ADDENDUM FIVE

NEW TERMINAL BUILDING AT
DUPLIN COUNTY AIRPORT

Date: **January 16, 2012**

ADDENDUM NO. FIVE

AD-E5-01

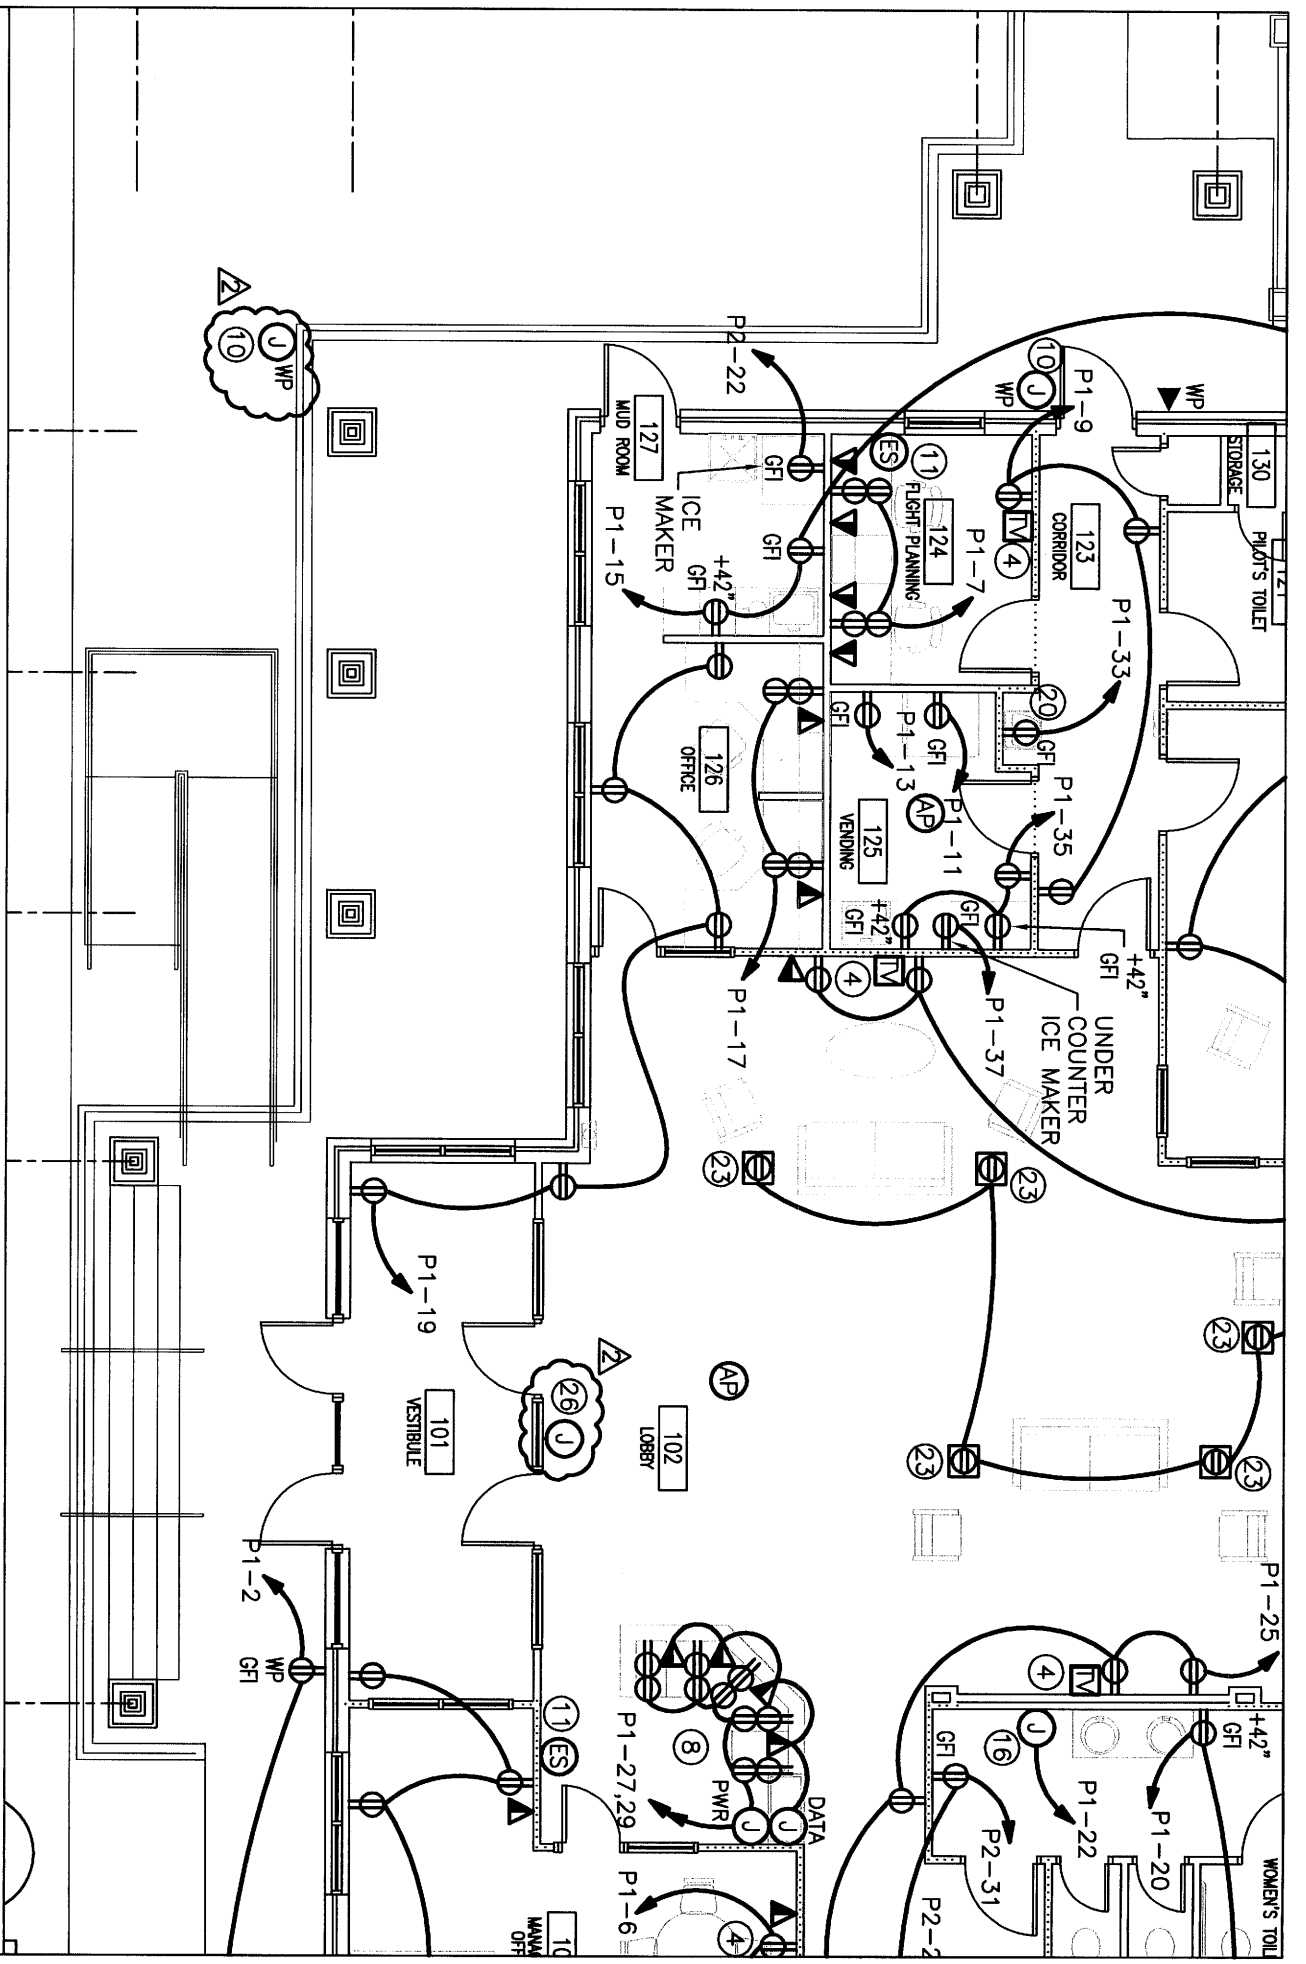
Sheet E102 (*Sketch AD-E5-01*)

- Added Junction box for future camera to Detail 6.

IF ALTERNATE #E1 IS ACCEPTED, THEN
CONNECT TO EXTERIOR LIGHTING CIRCUIT

PORTE COCHERE LIGHTING PLAN – ALTERNATE #E1

JANUARY 16, 2012
 11033
 AD-E5-02

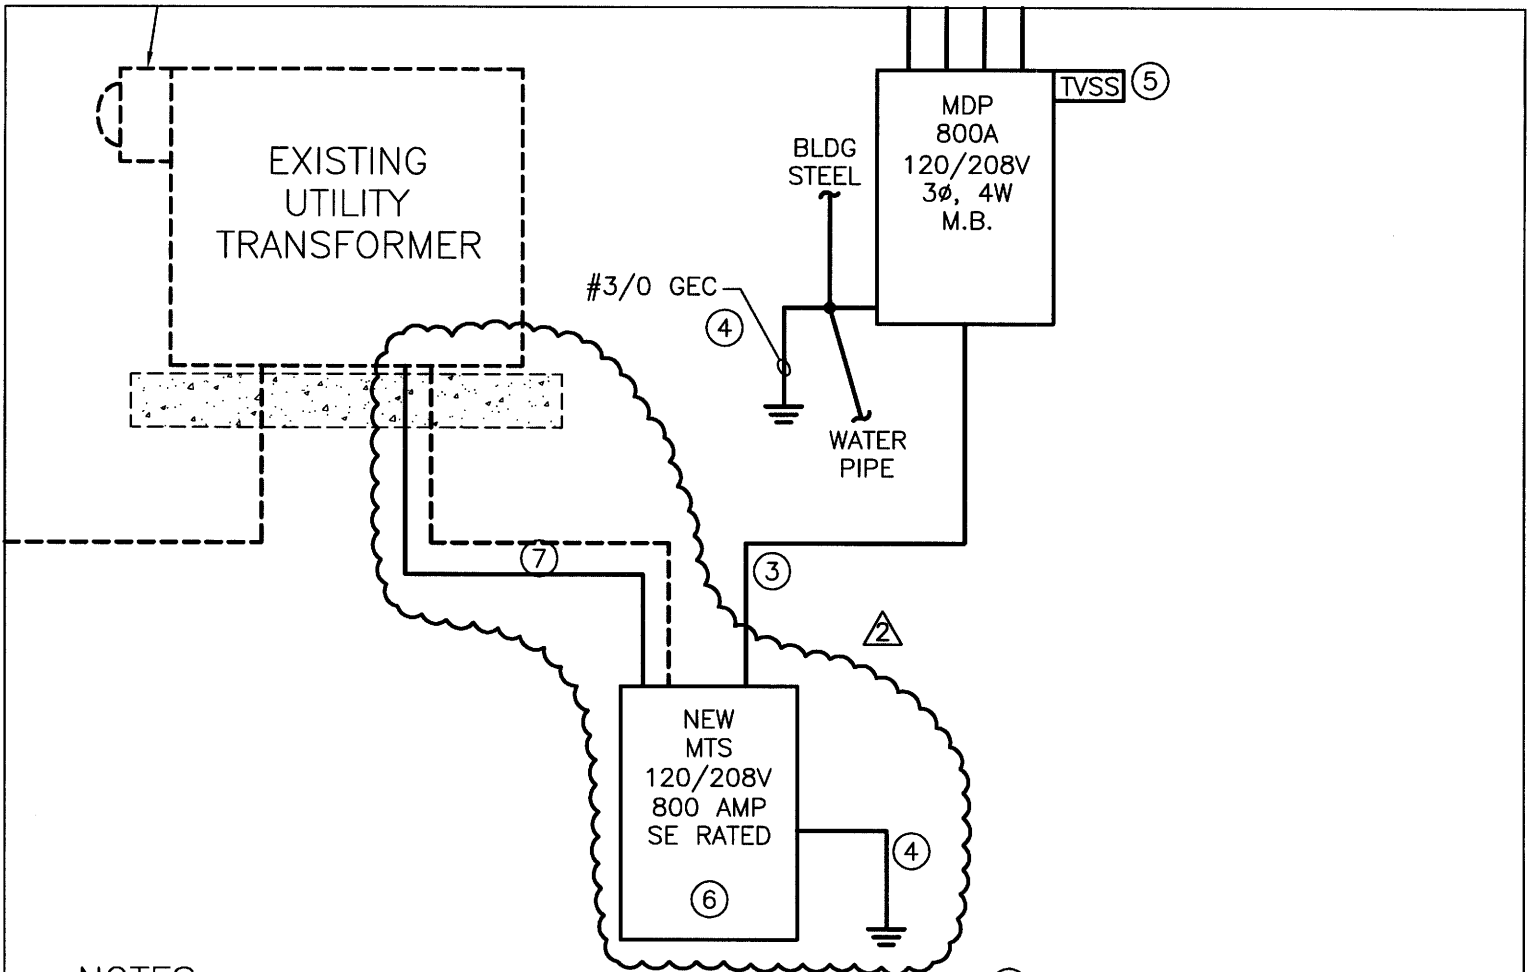
Sheet E103 (*Sketch AD-E5-02 thru AD-E5-03*)

- Added Junction box for future cameras in several locations.

THIS SKETCH IS TAKEN FROM SHEET E107 OF THE PROJECT DRAWINGS.

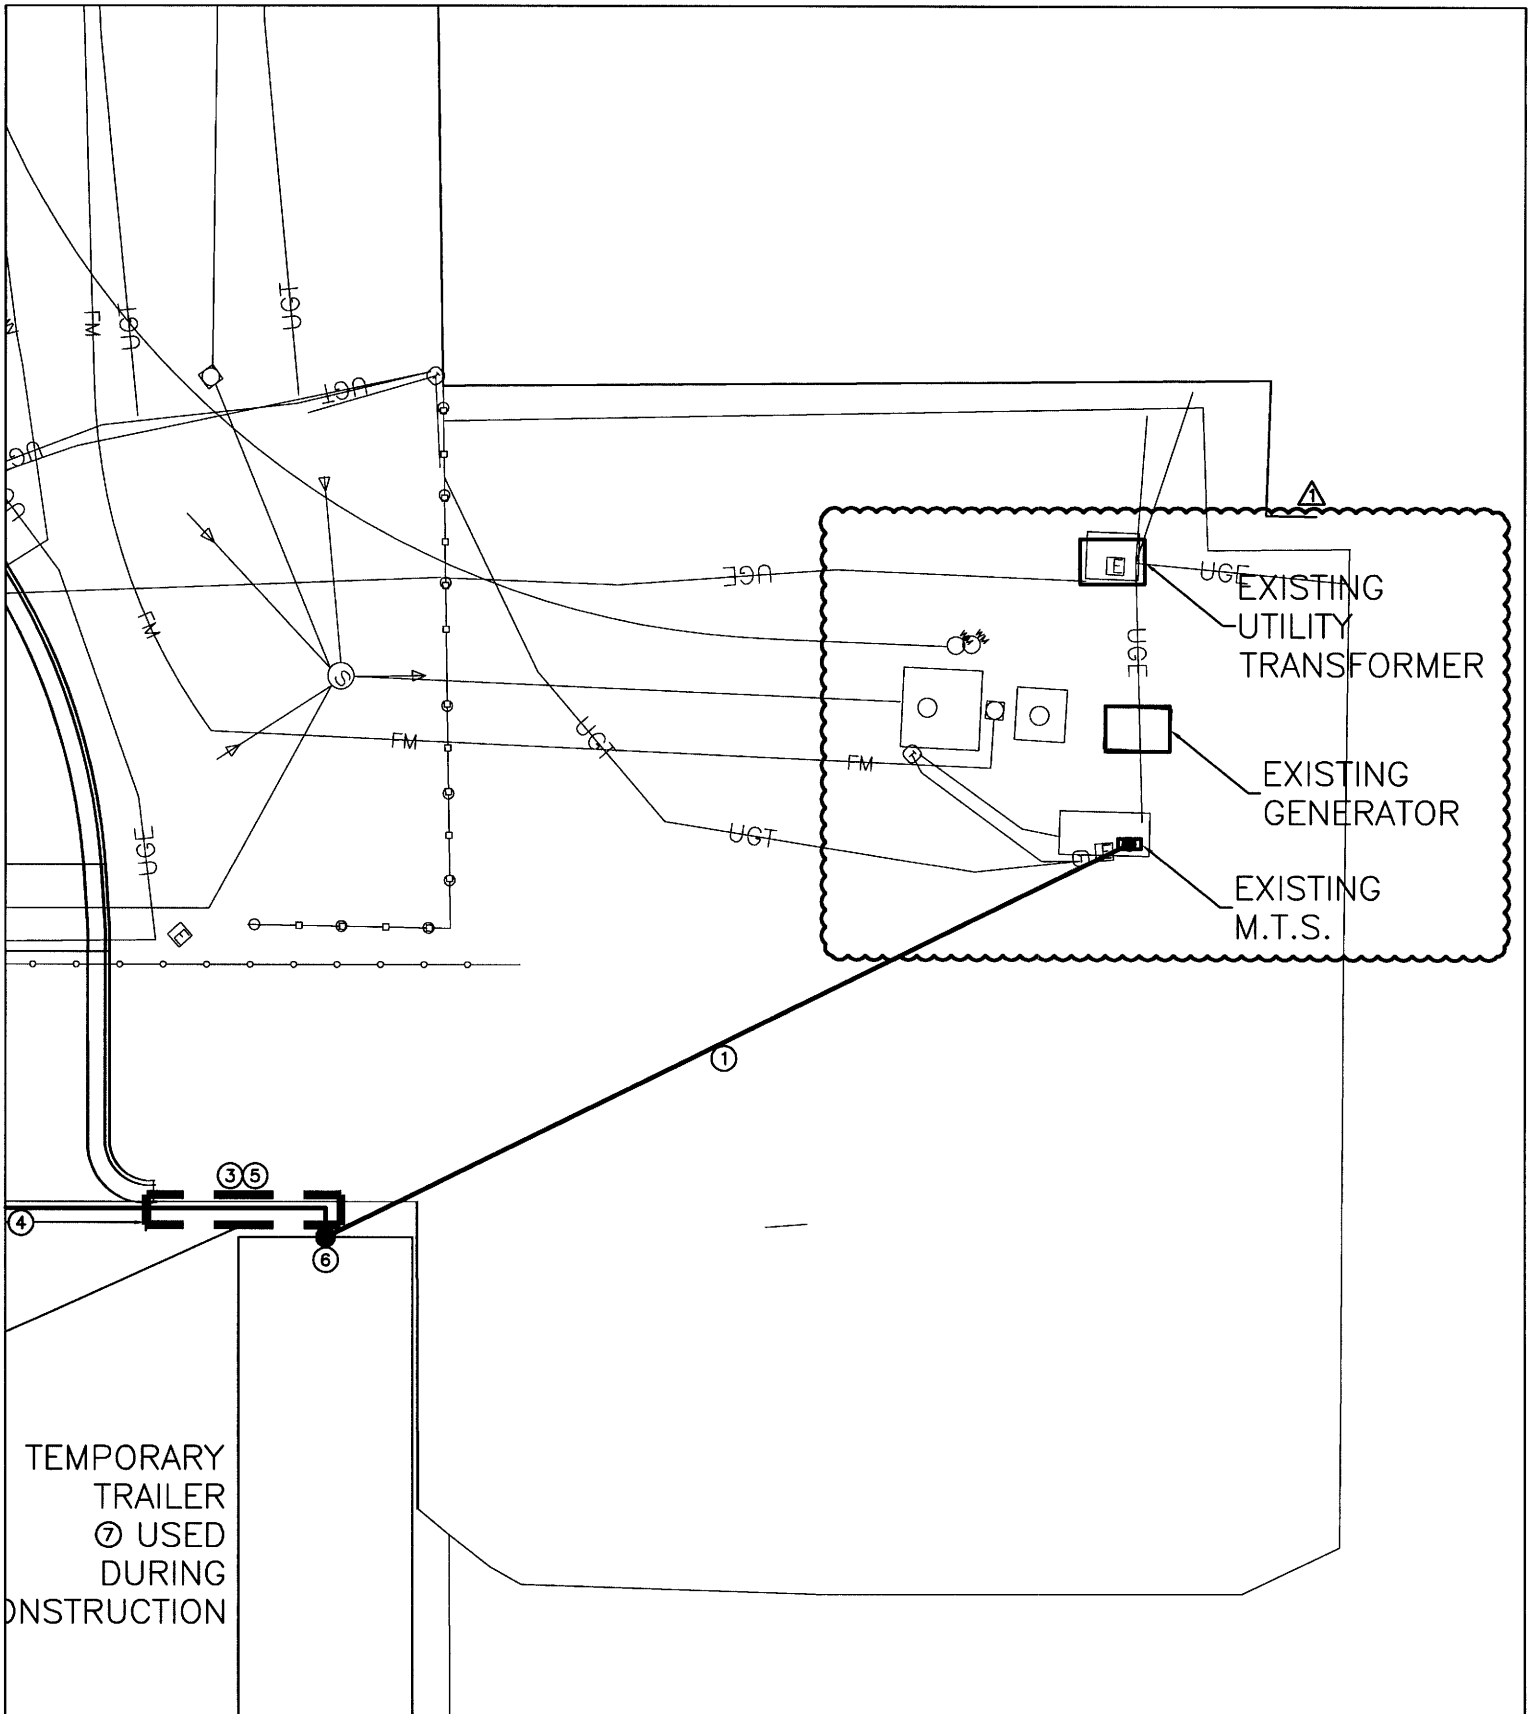
Sheet E107 (*Sketch AD-E5-04*)

- Changed new work riser detail.

- ⑥ DISCONNECT AND REMOVE EXISTING 400 AMP MANUAL TRANSFER SWITCH. UTILITY FEEDER, AND GENERATOR FEEDER ARE EXISTING TO REMAIN. CONTRACTOR SHALL PROVIDE NEW 800 AMP MAUNAL TRANSFER SWITCH AND CONNECT NEW FEEDER, EXISTING UTILITY FEEDER, AND EXISTING GENERATOR FEEDER TO NEW NEW MANUAL TRANSFER SWITCH. ⚠

- ⑦ CONTRACTOR SHALL PROVIDED AN ADDITIONAL PARALLEL RUN OF 4#500kCMIL IN 3 1/2"C BURIED A MINIMUM OF 48" BELOW GRADE TO TOP OF CONDUITS. EXISTING SERVICE IS ONE SET OF OF 4 #500Kcmil IN 3 1/2" CONDUIT. AN ADDITIONAL RUN OF 4#500kCMIL IS REQUIRED FOR A NEW 800 AMP SERVICE.
